SOUTH CAROLINA ELECTRIC & GAS COMPANY

Subject: Virgil C. Summer Nuclear Station
Docket No. 50/395
Operating License No. NPF-12
Spent Fuel Pool Rerack Modification

FIG. 2-1 MODULE LAYOUT

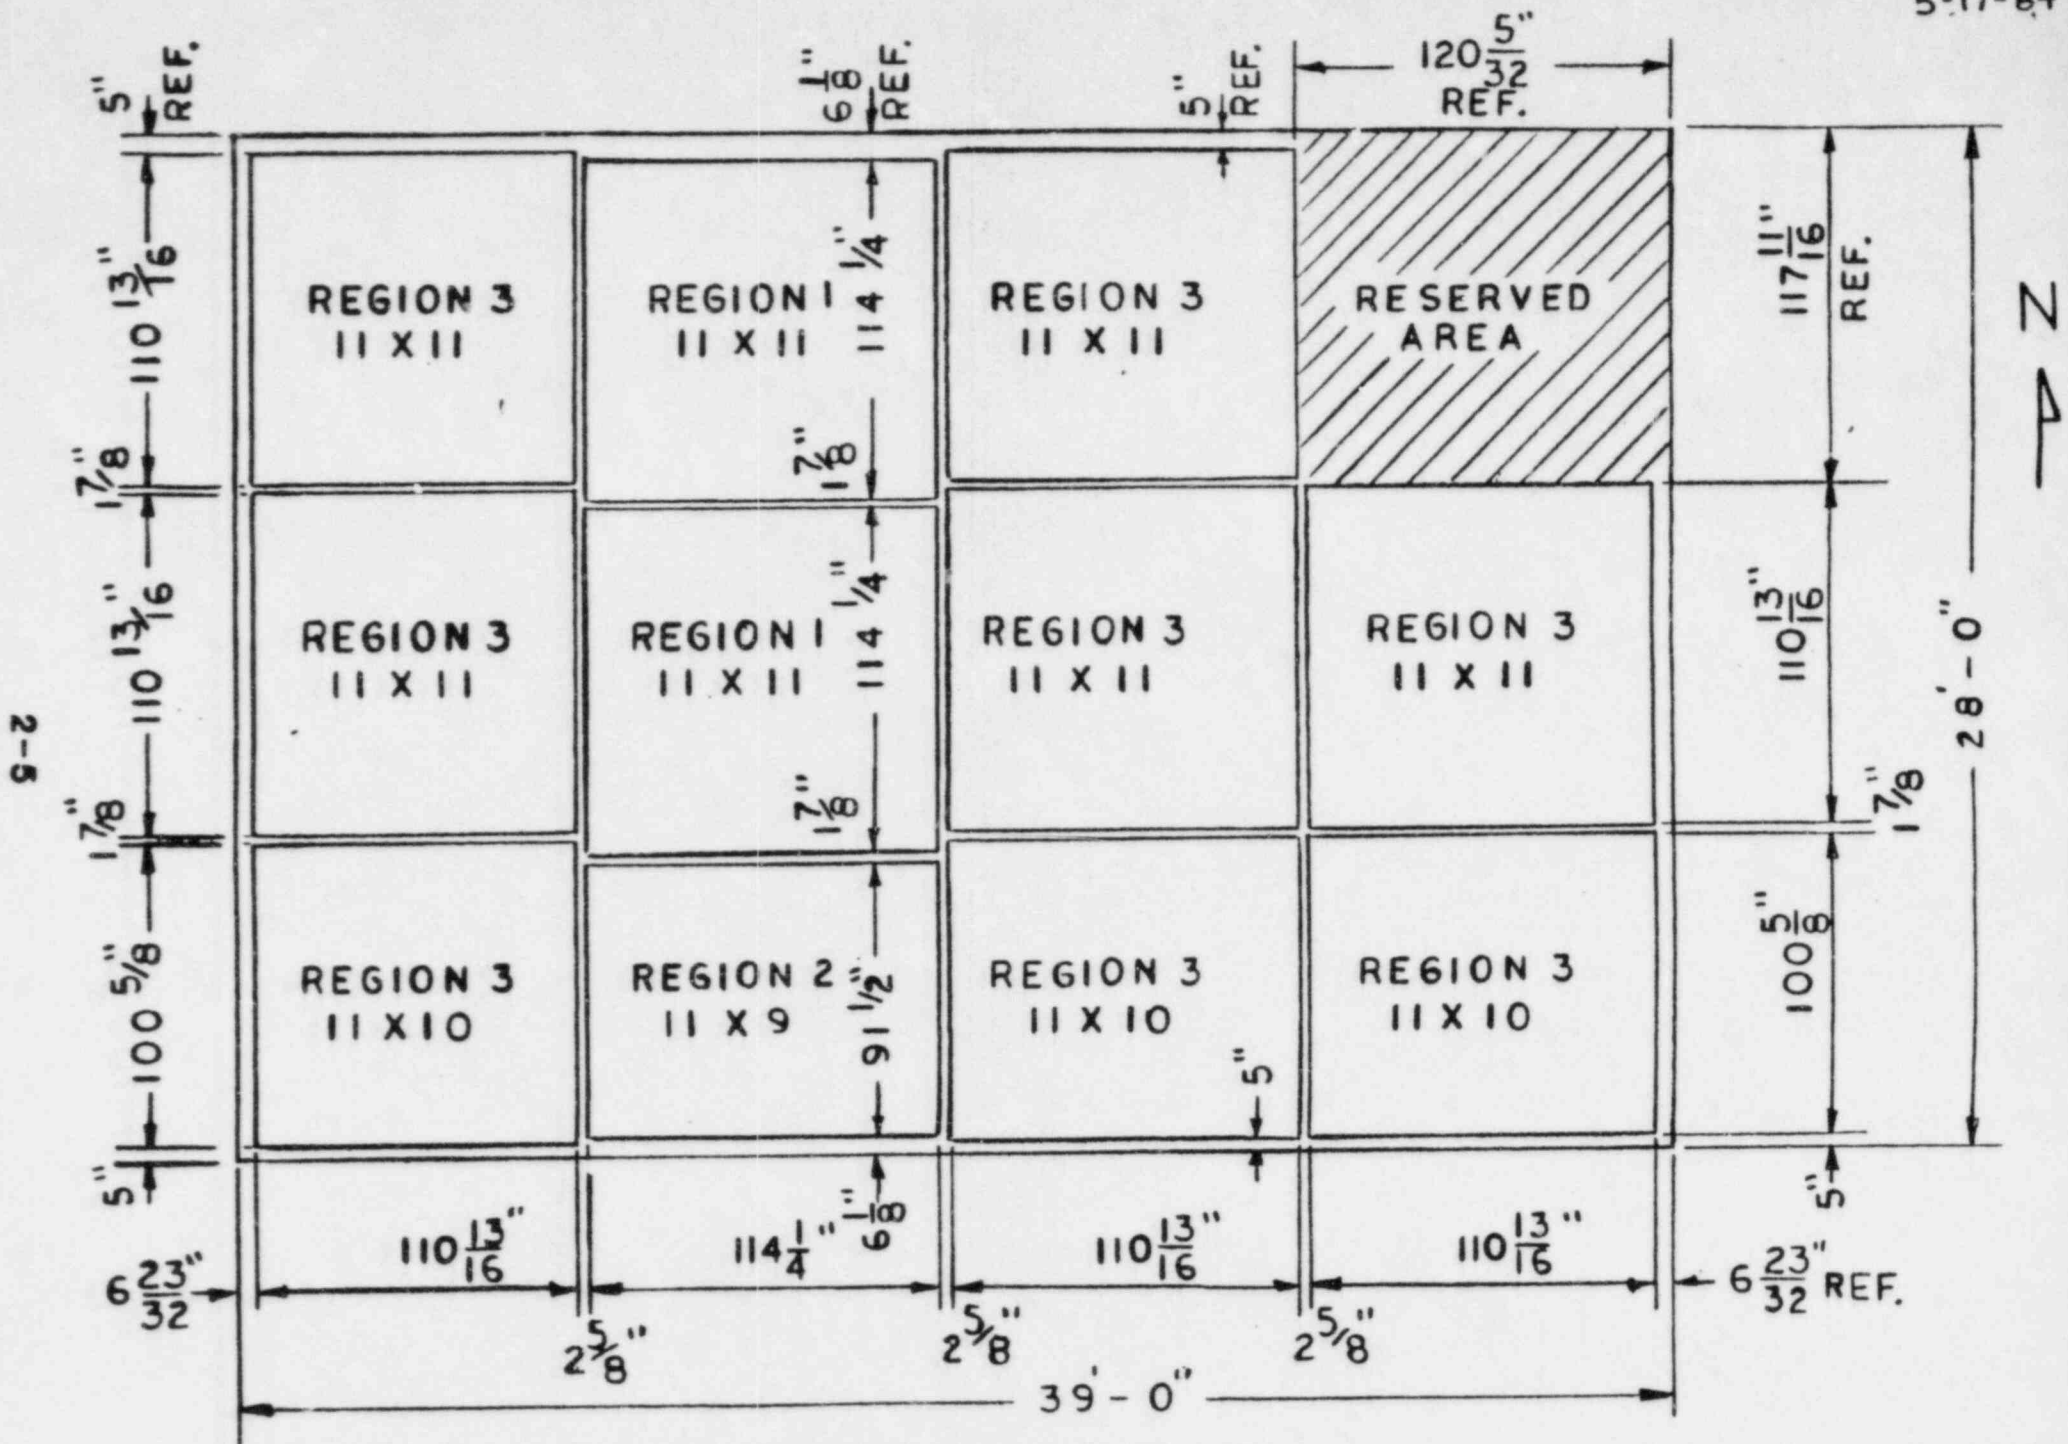
The fourth question concerns the possibility of heavy loads being moved into the area of the spent fuel pool designated as the "Reserve Area" (see Figure 2.1, enclosed). This "Reserve Area" can not be used as a cask loading area. The Fuel Handling Building crane is not capable of traveling over the spent fuel pool. Only the fuel handling machine can be operated over the area of the spent fuel pool. The "Reserve Area" would be used for operations, i.e., fuel sipping, assembly reconstitution, etc.
